**ADMINISTRATIVE RECORD  
FOR THE MADISON SITE  
MADISON, ILLINOIS**

Written Public Comments and Corresponding Responses  
to Comments

SUBJECT: Responses to Comments on the Remedial Investigation Report and Feasibility Study for the Madison Site

SUBJECT: Transmittal of USACE Responses to IDNS Comments on the Final Madison Site Remedial Investigation/Feasibility Study and Proposed Plan, January 2000

Figure 1. Approximate Sample Locations for Difficult to Access Areas

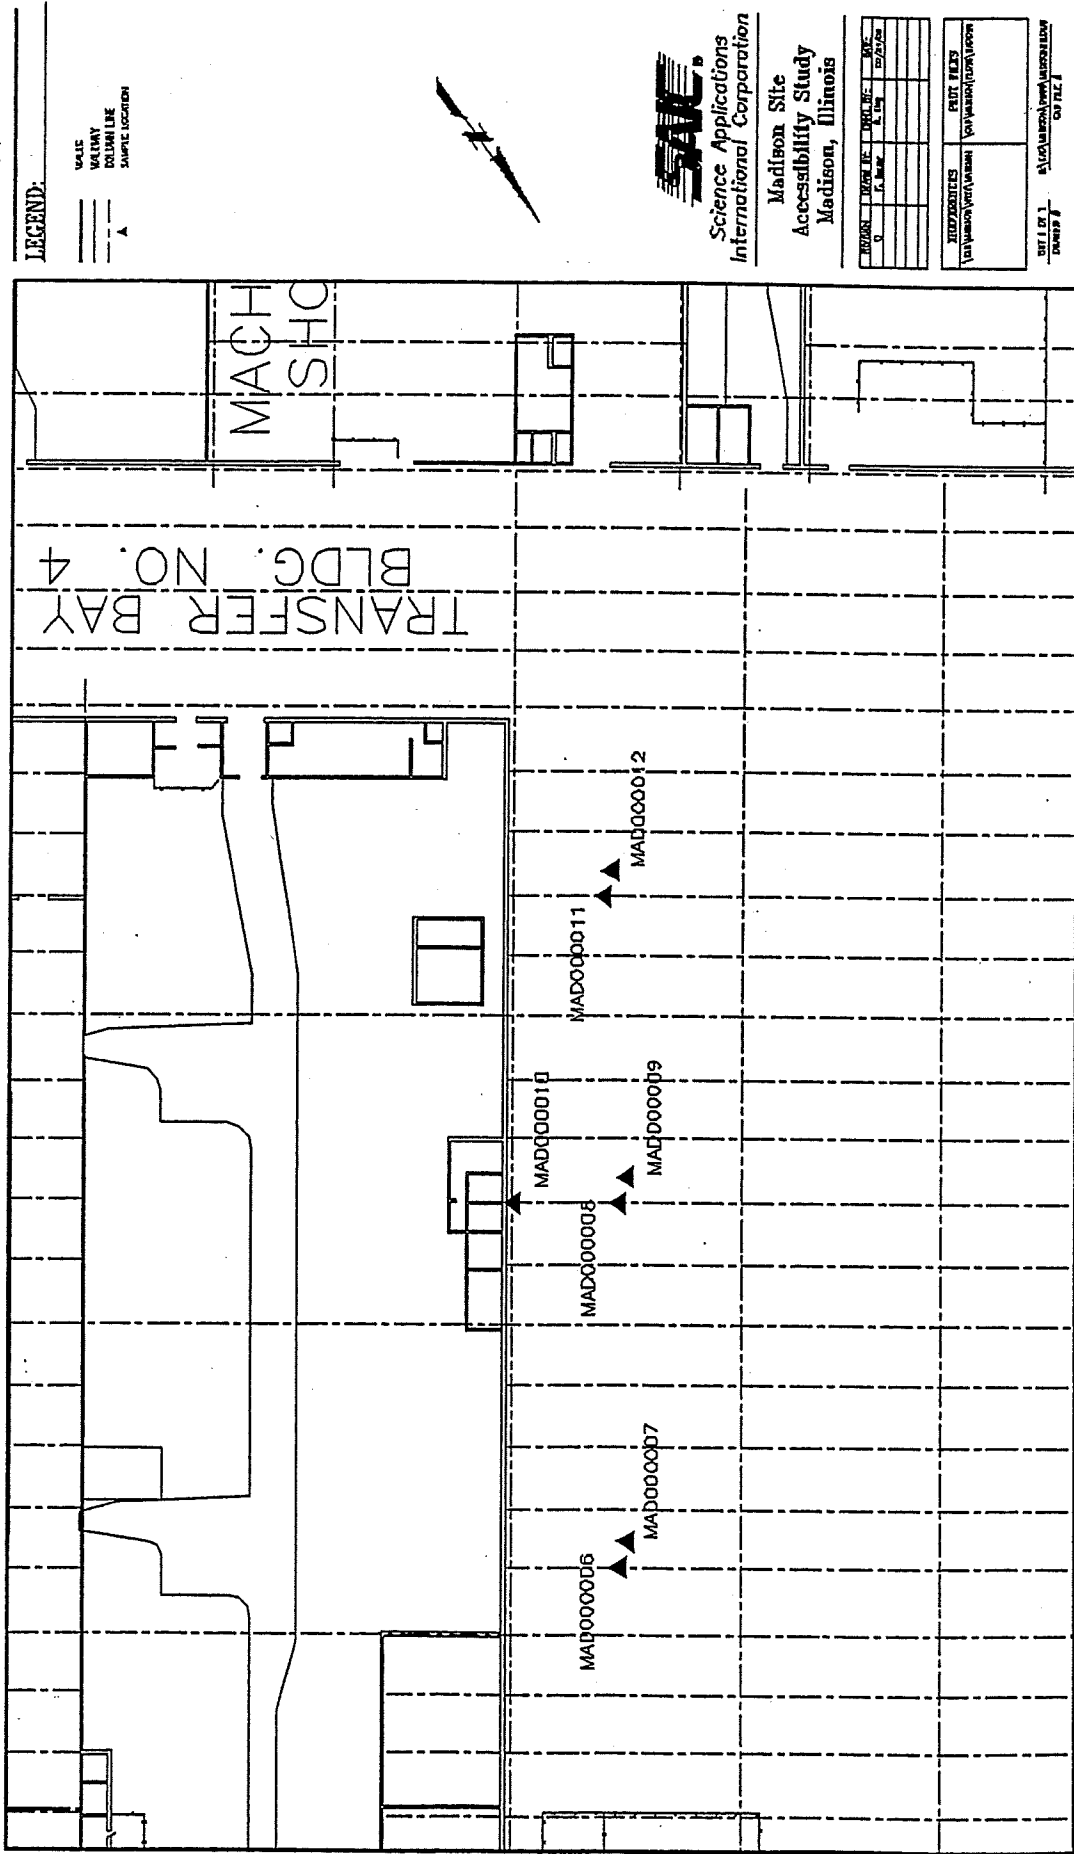
*Comment 6*—The Corps contends that "... [t]he difficult to access areas do not contribute to dose exceeding 25 mrem/yr" (page 3-4, Feasibility Study for the Madison Site.) This statement is suppositious, since the Corps has failed to adequately characterize the contamination in these areas, and has failed to perform adequate risk assessments that cover the scenarios and time periods required by the NRC.

*Comment 9*—The Department is encouraged that the Corps has collected additional samples to further characterize contaminated areas. The first step described in decommissioning guidance is the characterization of the radioactive contamination ("source term" or "source"),

*Response 6*—USACE completed a supplemental assessment on March 8, 2000 of the material in the Difficult to Access Areas. This assessment (see Attachment 1 – Dose Assessment for Difficult-to-Access Areas at the Madison Site) shows that the dose from the material in the

*Response 9*—USACE has completed additional sampling and performed a supplemental risk assessment of the Difficult-to-Access Areas. The results of this assessment are enclosed. (Attachment 1).

The beam/sample locations presented in Table 1 are shown in Figure 1. Figure 1 is based on the hand-drawn map used by field personnel during the sampling event. Figure 1 is not drawn to scale, but does illustrate the distribution of sampling locations in relation to previous sampling events and the extrusion press. For a comparison to previous sampling locations and concentration results (from lower/accessible beams in the study area) see Figure 1-4 from the Feasibility Study (USACE 2000).

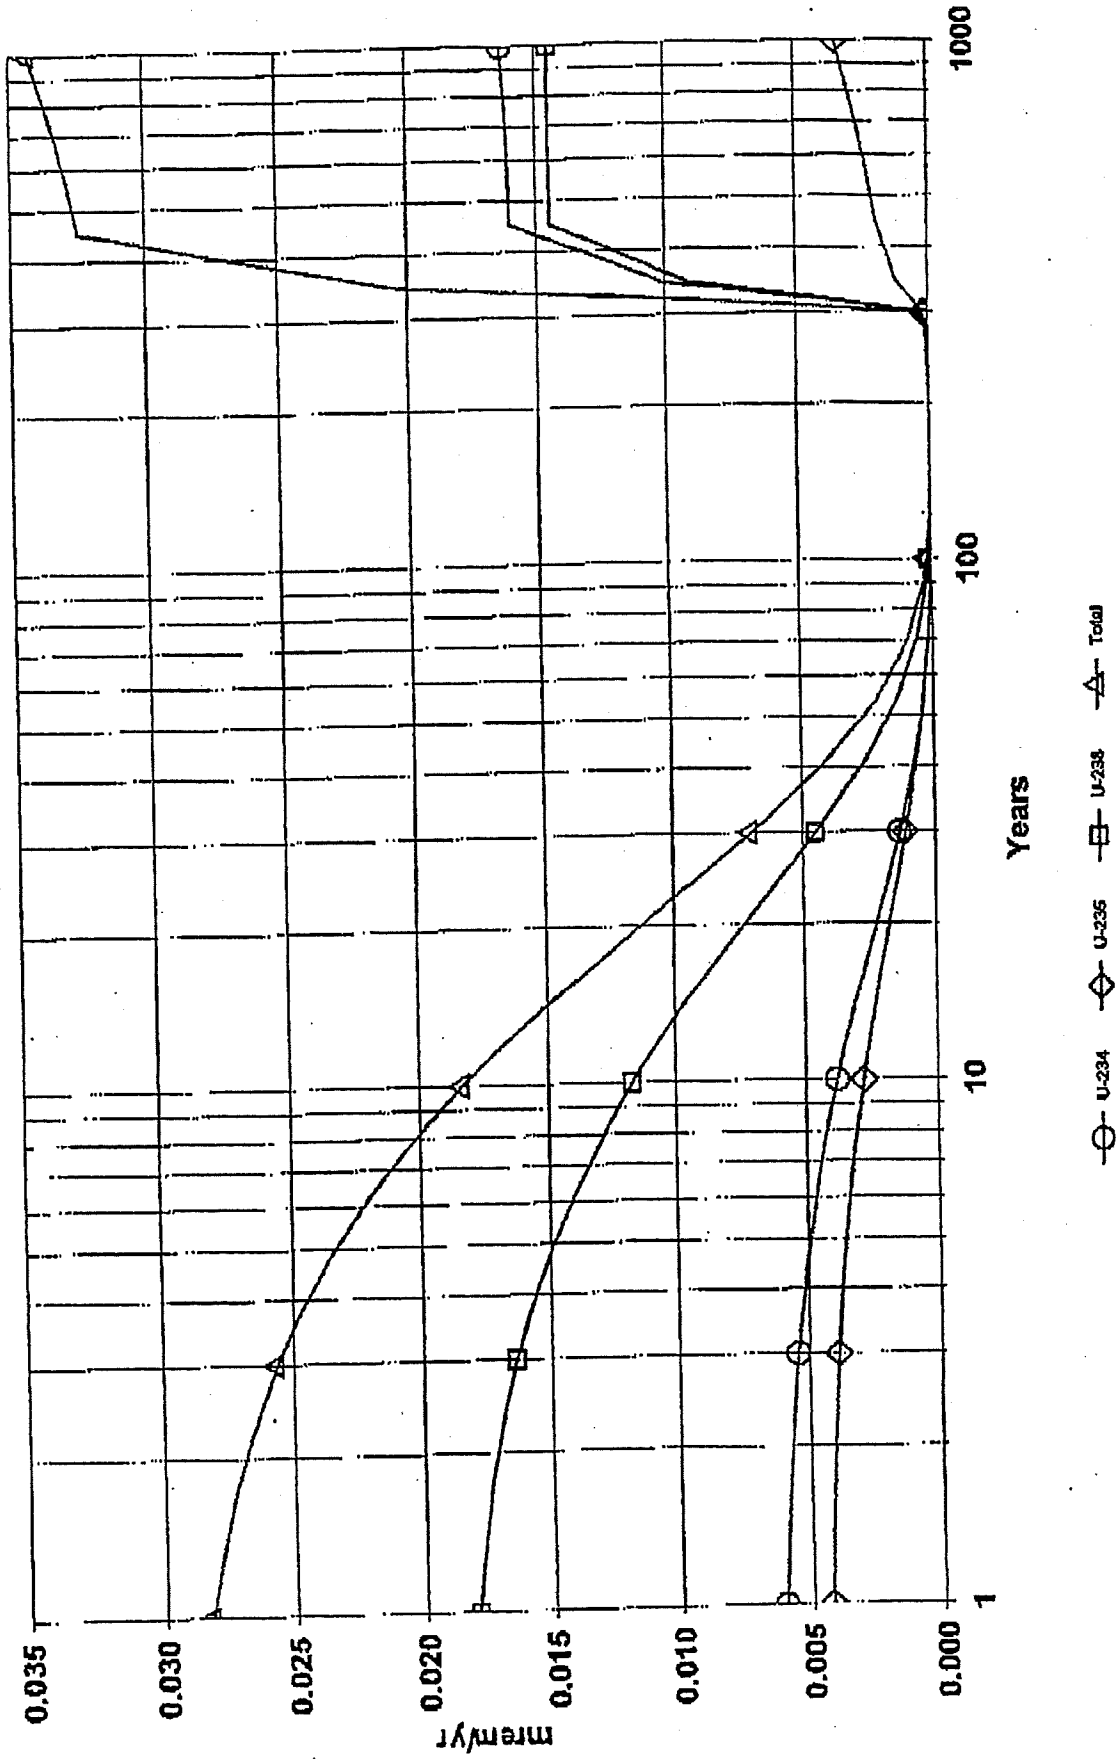
The "post demolition" segment of the required 1000-year dose assessment period should assume that the entirety of the structure's residual radioactivity is transferred to surficial soil after the building is demolished. The assumed "footprint" of the contaminated soil may consider scattering due to demolition and grading, but should not exceed 200% of the original contaminated area of the building (not the entire building). RESRAD and DandD codes can then be used to model the estimated dose from all pathways. Surficial soil is defined as being the topmost 15 centimeters. MARSSIM does not address subsurface soil contamination beneath 15 centimeters. RESRAD is appropriate for modeling.

Here is our RESRAD RUN. IT shows the peak dose is in the first year, and due to dispersion goes to "0" just over a 100 years. The 1000 yr spike is an artifact in the model and is not relevant.
